WATER RESOURCES DEPARTMENT MEMO

TO: Application G- 17999
FROM: Phillip Marcy - Groundwater Section
SUBJECT: Scenic Waterway Interference Evaluation

PUBLIC INTEREST REVIEW FOR GROUNDWATER APPLICATIONS

TO: Water Rights Section Date 05/27/2015
 FROM: Groundwater Section Phillip I. Marcy / Ivan K. Gall
Reviewer's Name
 SUBJECT: Application G- 17999 Supersedes review of _____
Date of Review(s)

Figure 1: Map showing location of the proposed POA, in relation to the Malheur River and state observation wells MALH 1222 and MALH 1062.

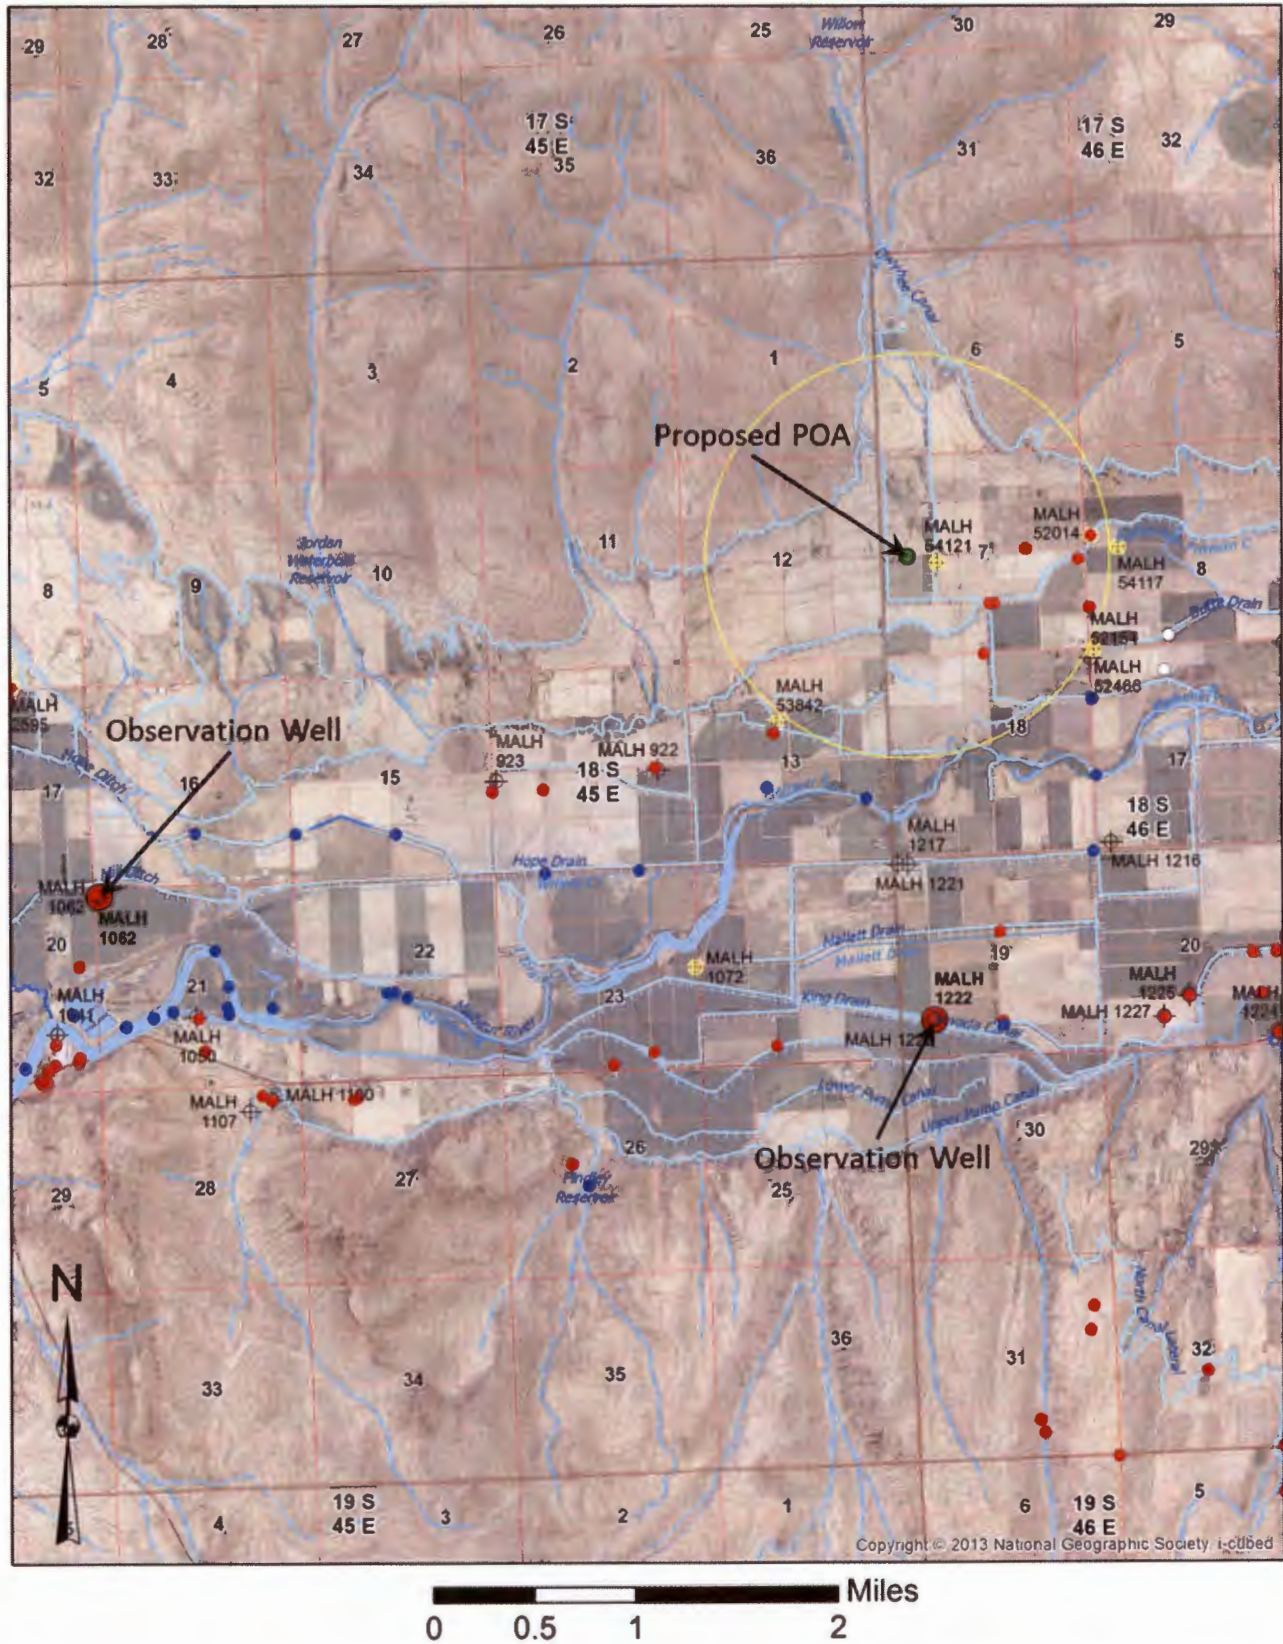
B3. **Groundwater availability remarks:** Based on the descriptions of lithology on the well log, the water –bearing zone in the applicant’s well (MALH 52491) occurs within sand and gravels overlying the Glenns Ferry Formation (Tig of Brooks and others, 1976). The production zone of sands and gravels is relatively thin (14 feet), but likely to be highly transmissive. Aquifer tests by Gannett (1990) estimate a range of hydraulic conductivities in the area between 400 ft/day and 670 ft/day. The resulting transmissivity for the sand and gravel aquifer at this location ranges from 5600 to 9380 ft²/day. Observation well data show groundwater levels in the area have been stable for decades (Figure 2) in the shallow alluvial aquifer system. Due to the thin nature of this aquifer, it is recommended that a modified measurement condition be emplaced to protect nearby senior groundwater right holders from possible interference (see below).

If a permit is issued, the following conditions should apply: 7T – measuring tube condition;
Modified Condition 7N (annual measurement condition) - The water user shall discontinue the use of, or reduce the rate or volume of withdrawal from, the well(s) if any of the following events occur:

Figure 2: Water levels in nearby observation wells have remained stable for decades.

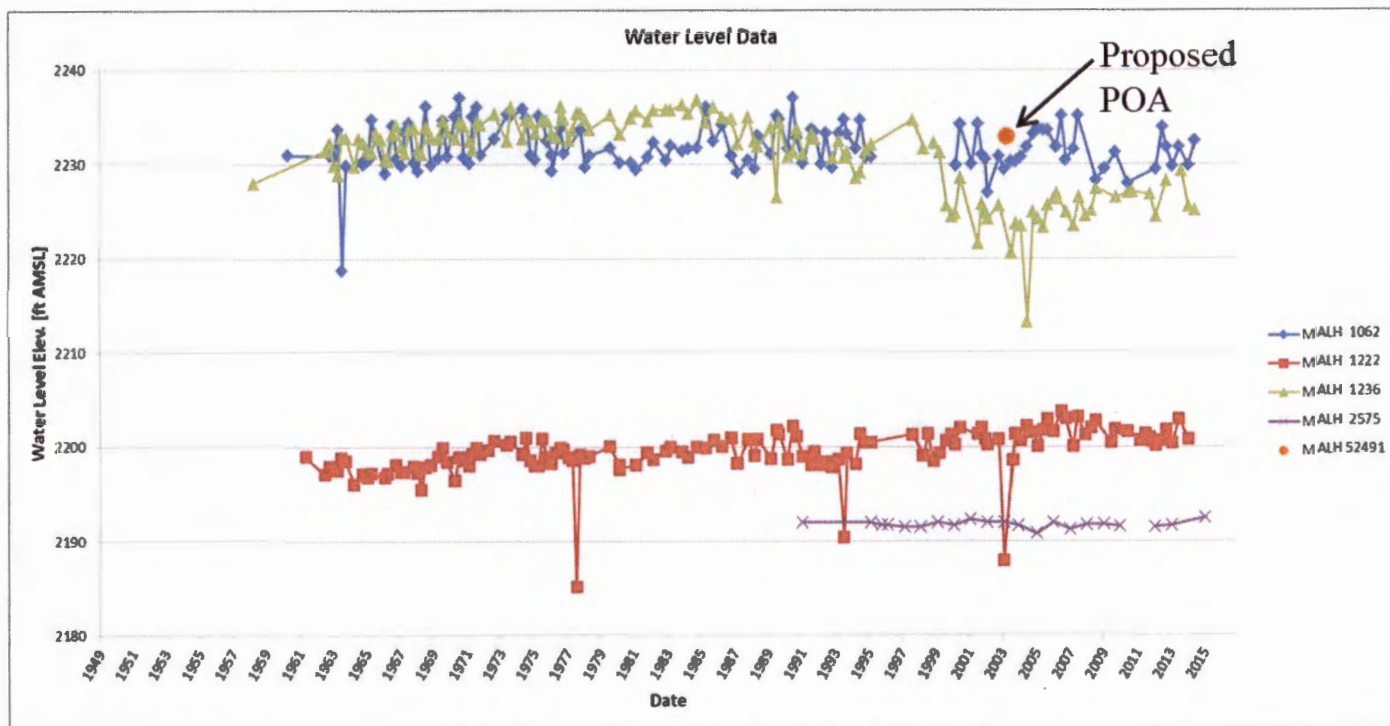
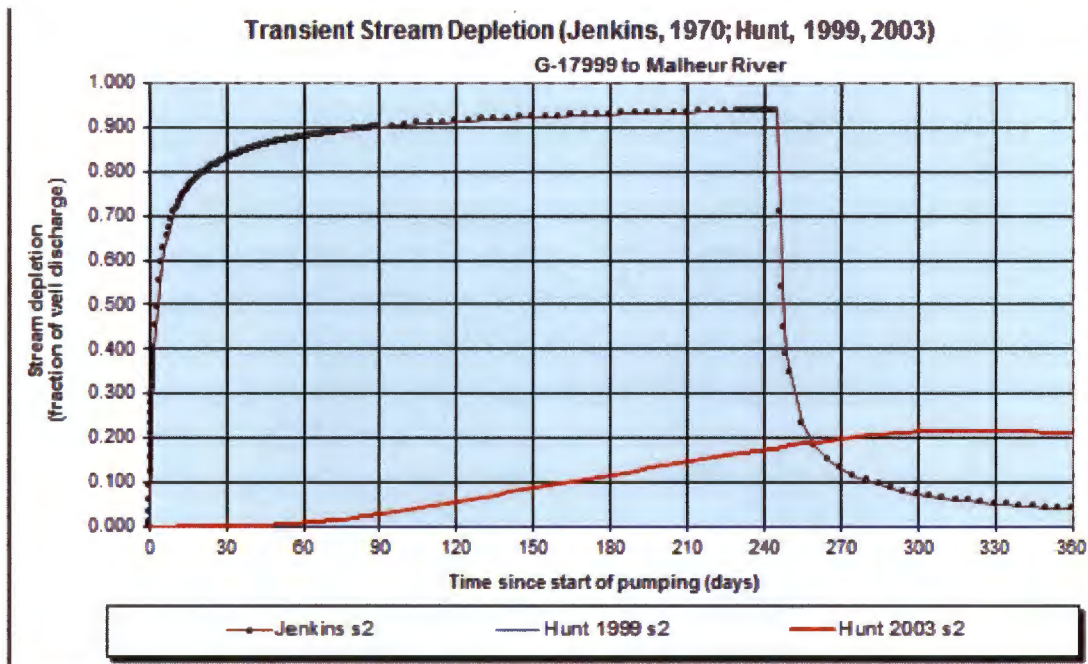
C6. **SW / GW Remarks and Conditions:** The connection of the proposed POA to the Malheur River is inefficient, and given the distance and the rate proposed, does not have the potential to cause significant injury to surface waters. Leakage from local canals and ditch systems are major sources of recharge to the shallow sand and gravel aquifer system (Gannett, 1990), and the effects of reducing the flow through these systems on recharge is yet to be determined. For this reason, consistent annual measurements should be performed, according to the special condition described above (see B3).

- A. Annual water-level measurements reveal an average water-level decline of **two or more feet per year for three consecutive years;** or
- B. Annual water-level measurements reveal a water level decline of **6 or more feet** in fewer than five consecutive years; or
- C. Annual water-level measurements reveal a water-level decline of **10 or more feet;** or
- D. Hydraulic interference leads to a decline of **10 or more feet** in any neighboring well with senior priority.
